Northrop Grumman Corporation
Aeronautics Systems
One Space Park
Redondo Beach, CA 90278 U.S.A.

The F35 program is continuously striving for the highest quality standards to meet our increasing production rate. Recently, issues have been found related to fillet relief which impact production and incur additional cost.

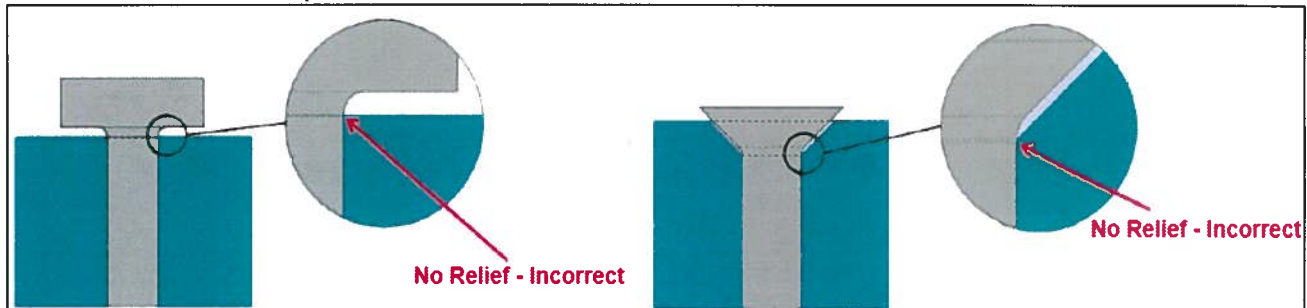
Inadequate fillet relief may create a gap and/or improper seating condition as shown below, which results in additional impacts to the program.

As a result of these findings NGC is requesting that our supply base review their current manufacturing instructions and inspection processes to ensure adherence to the fillet relief requirements given in LMA-PL011, section 3.3.7.

Please identify product where this requirement applies and review your manufacturing plans / work instructions to ensure hole drilling operations are incorporating the fillet relief / deburr requirements. If no product is affected, respond to this bulletin indicating "No Product Affected".
